## **THM 4L60, 4L60-E, 4L65-E**

### **NEW 29 ELEMENT SPRAG WITH DUAL CAGE**

**29 ELEMENT, DUAL CAGE SPRAG  
FROM BORG-WARNER CORP.  
PART NUMBER 29236AM**

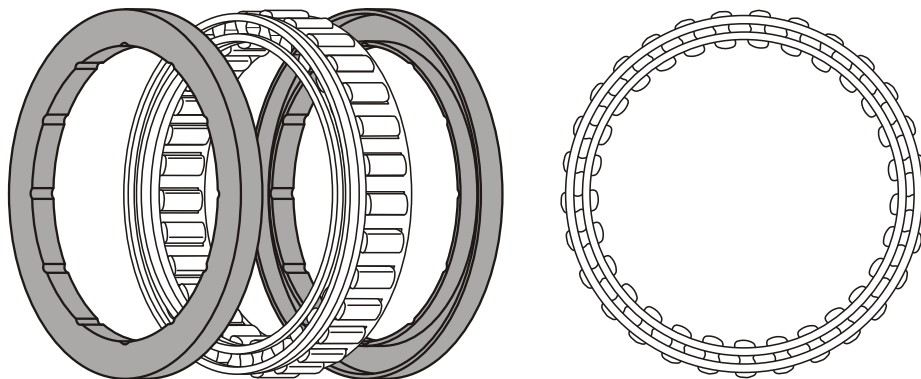
Borg-Warner Corporation has now released a new design 29 element input sprag with a dual cage, as shown in Figure 1. This new product will retro-fit back on all 4L60 (700-R4), all 4L60-E and the new 4L65-E transmissions. You will now have the extra load capacity of the 29 elements that replaces the previous 26 and 28 element sprags, and the extra stability of the dual cage over the current 29 element design from General Motors. This new design 29 element, dual cage input sprag is available under Borg-Warner part number 29236AM.
